# Parcels 14 & 15 CV Properties Proposal Design Review Feedback

I-195 Redevelopment District Commission Meeting  
May 17, 2023

# Master Plan Phasing

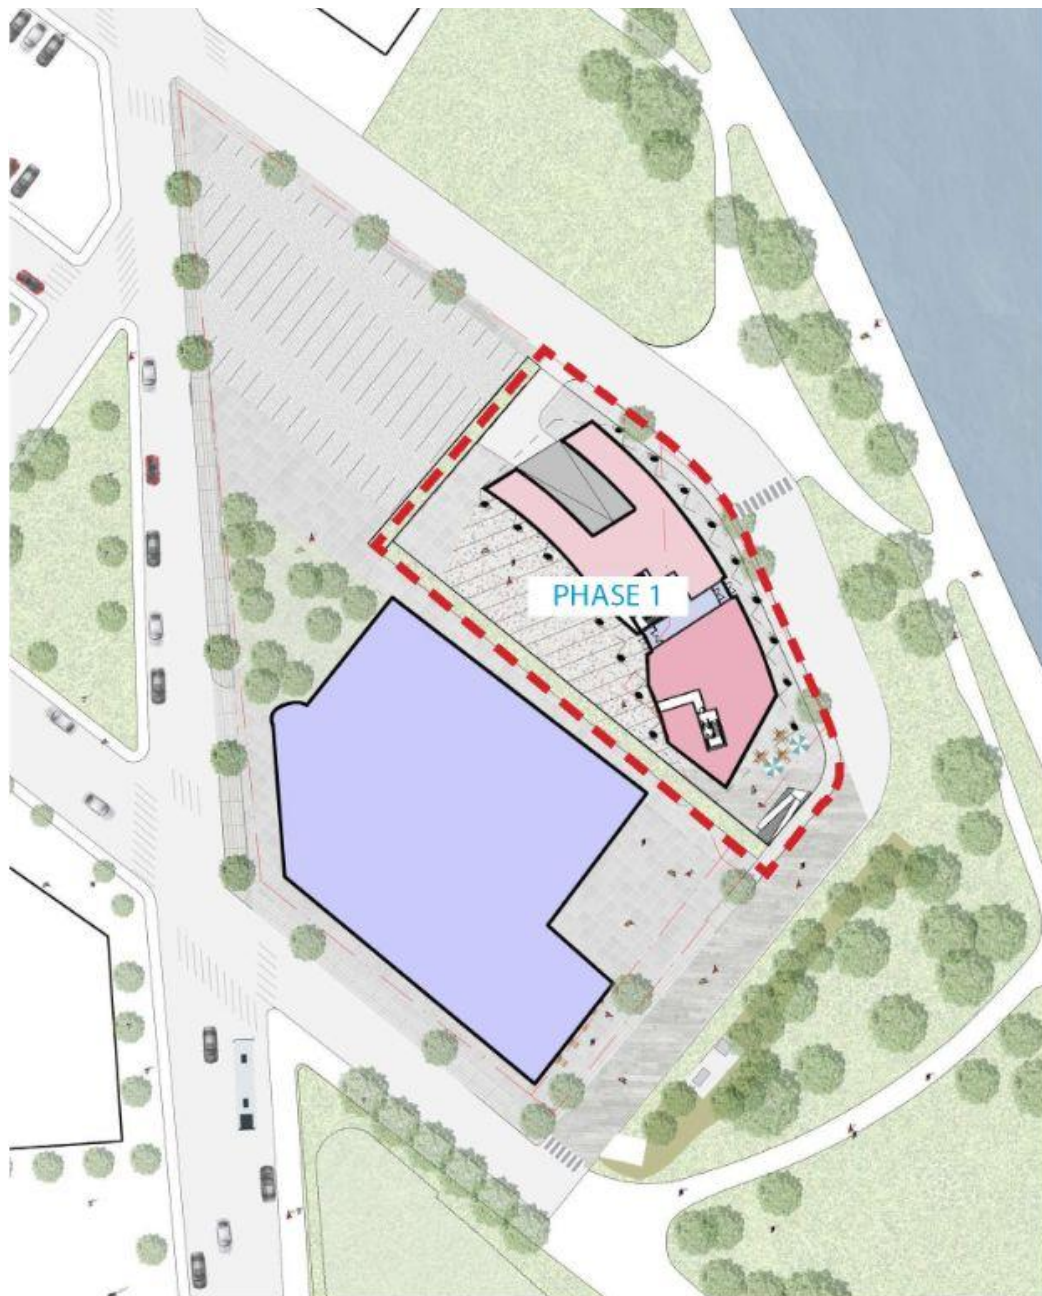
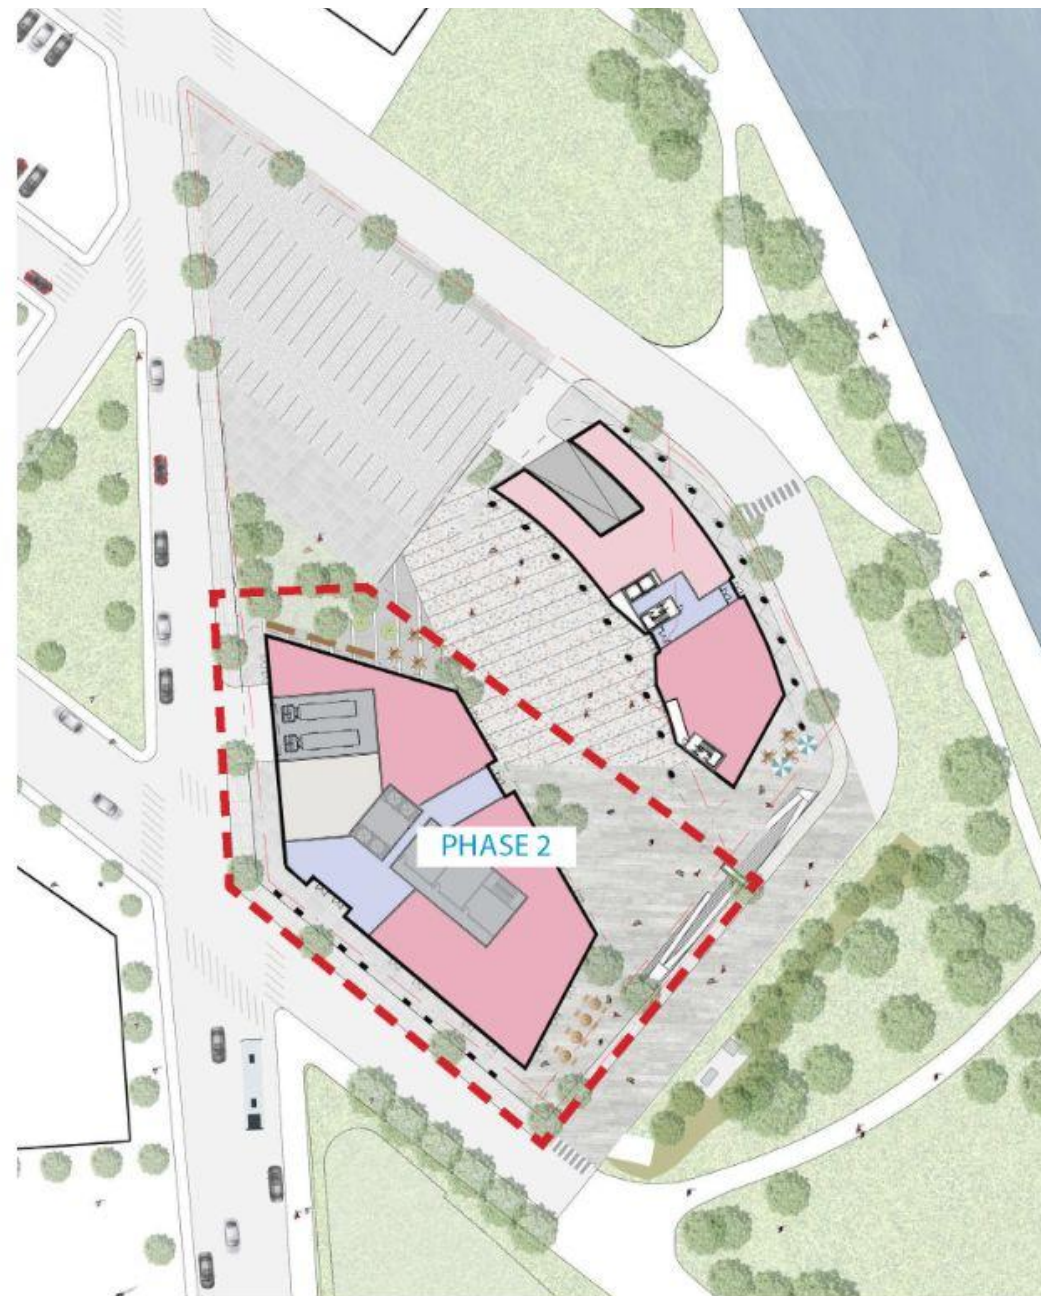
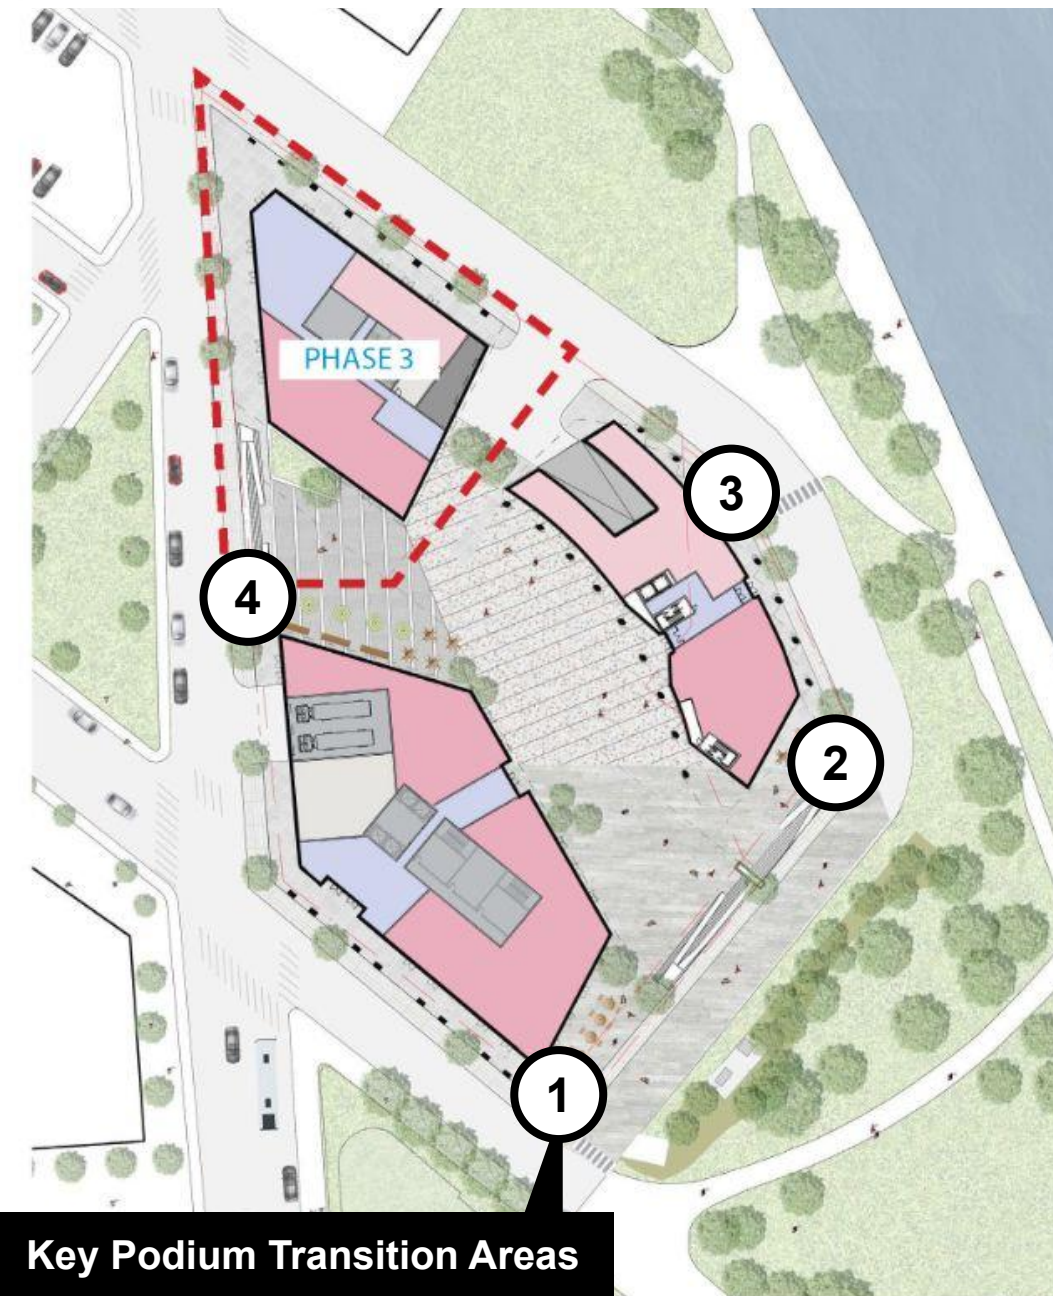
Because this is a phased development, the first phase of which is on District land, it will be critical to ensure that the interim condition at the completion of each phase creates logical public realm relationships and transitions at the ground level.

# Master Plan Phasing

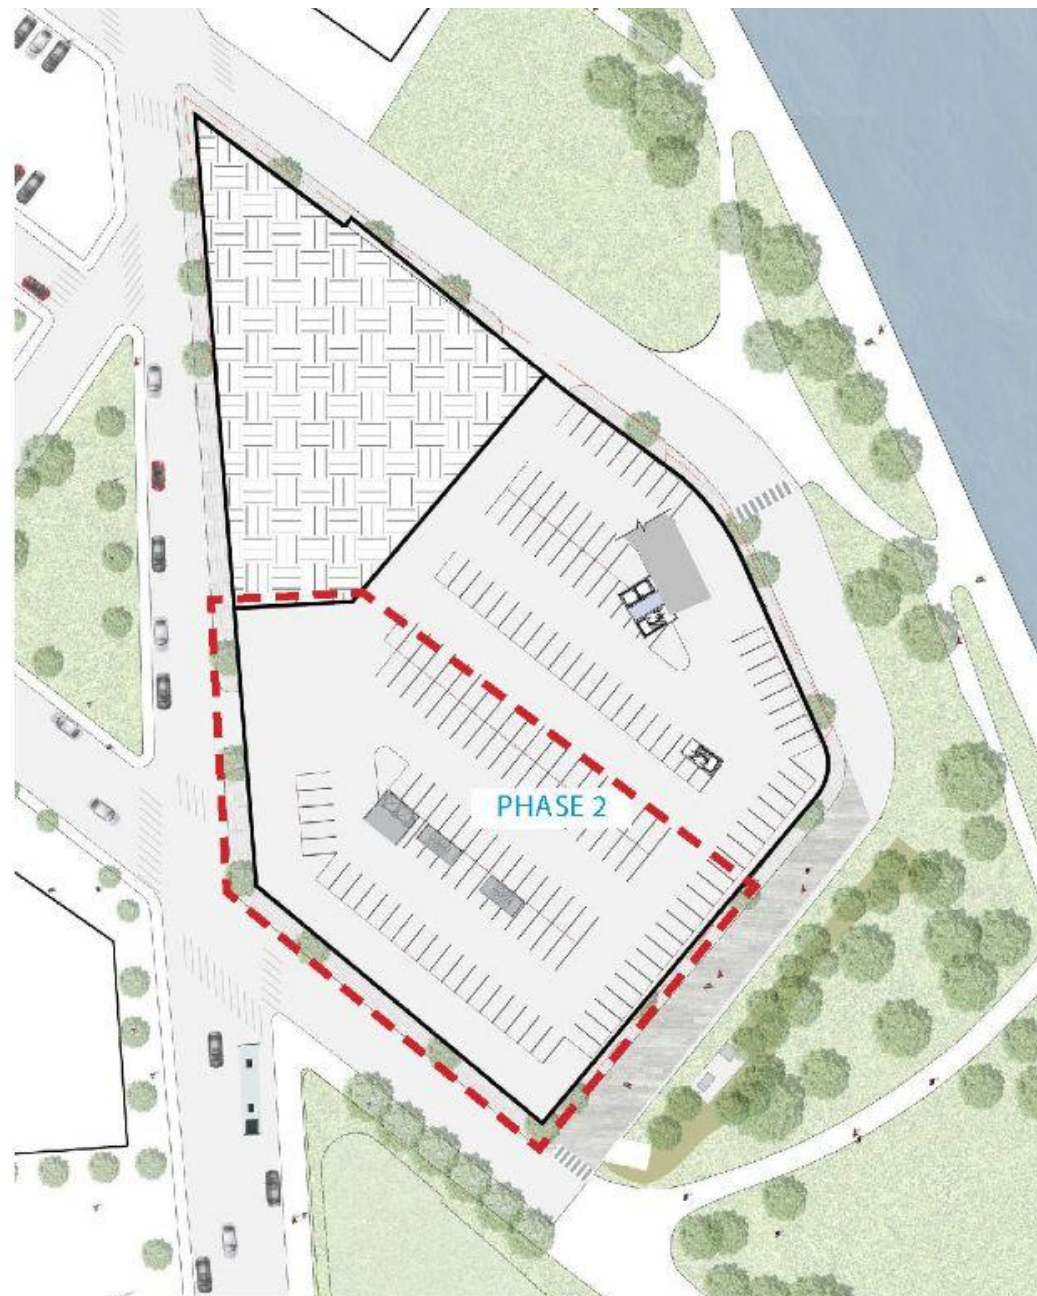
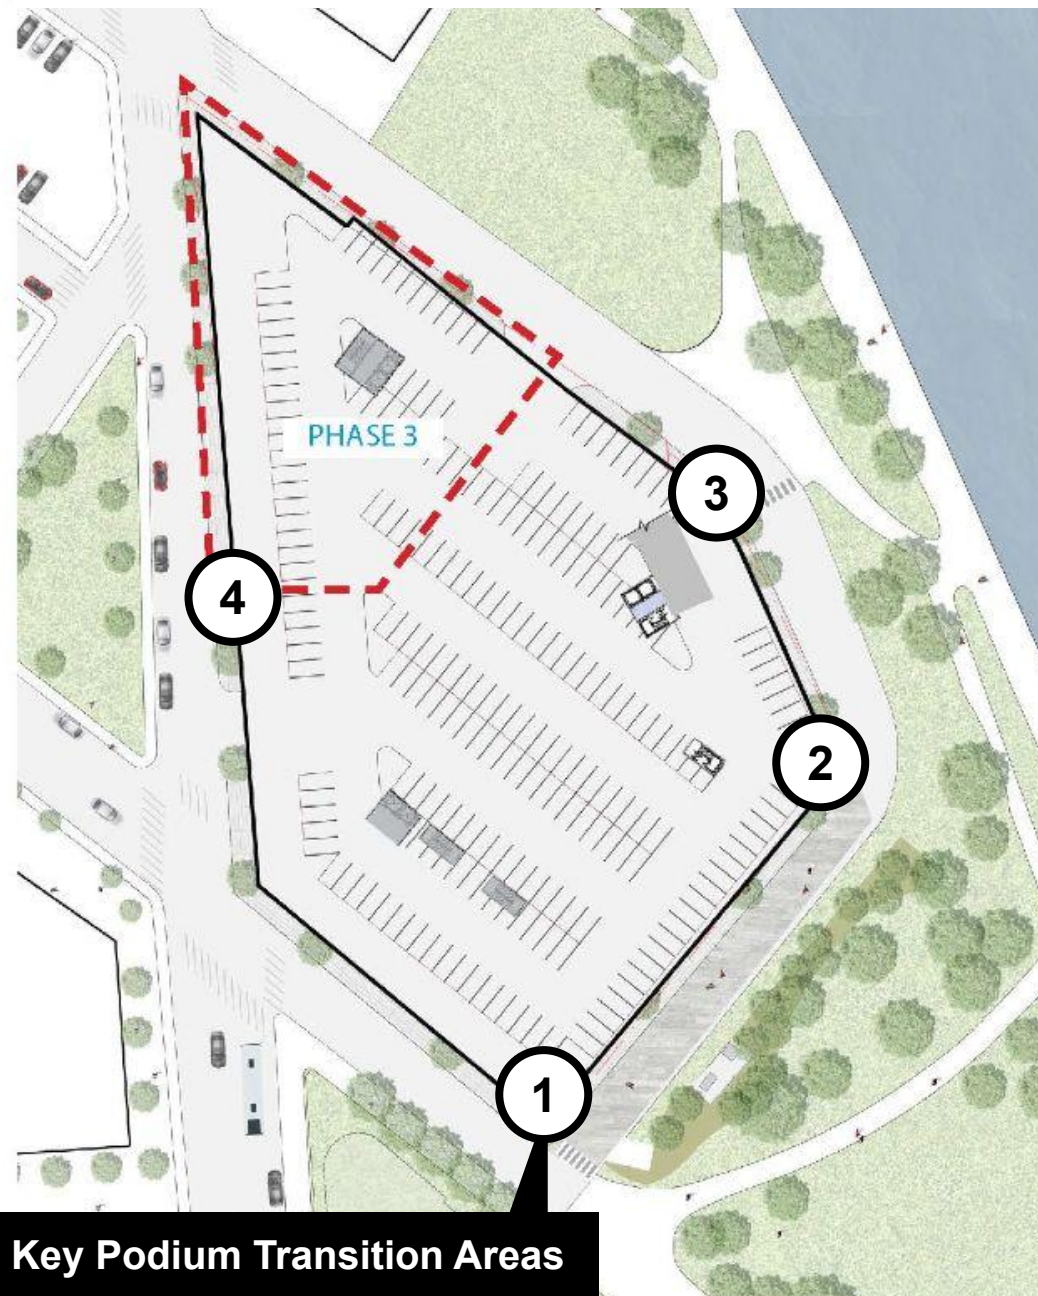
The layout and phasing of the below-grade parking has important implications for the public realm transitions - finessing the below-grade parking may enable more successful and gradual transitions from the sidewalk grade to the podium grade.

## Section Studies of Shared Podium Elevation Relationship to Public Realm on Peck Street

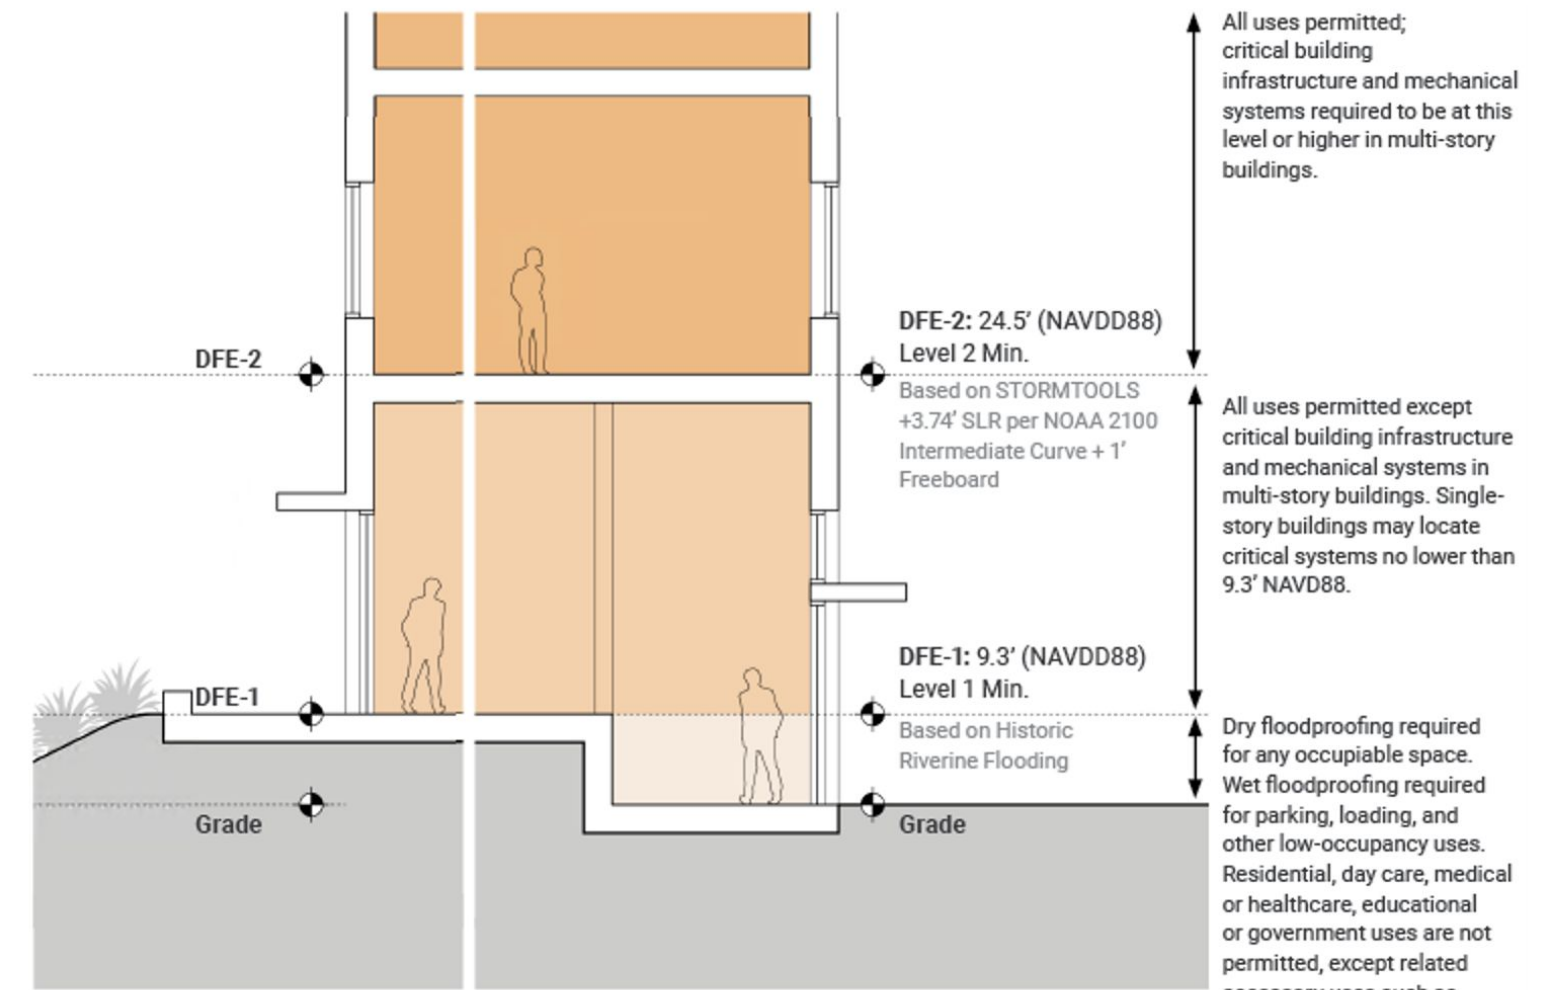
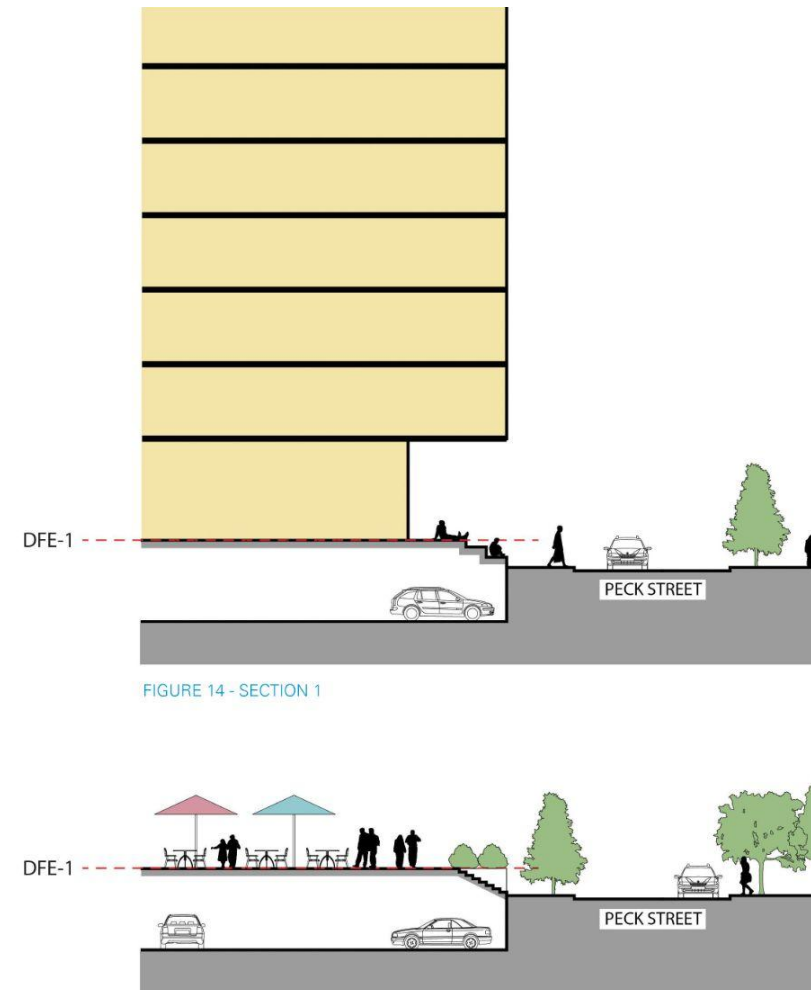
- The finish elevation of the podium is required to meet a 9.3' Design Flood Elevation (DFE-1) to protect the development from coastal flooding, which is part of what is driving this unified podium strategy.
- However, with some modifications to the underground parking it may be possible to create a more gradual transition with intermediate levels to create more continuity between the podium and sidewalk at key locations.
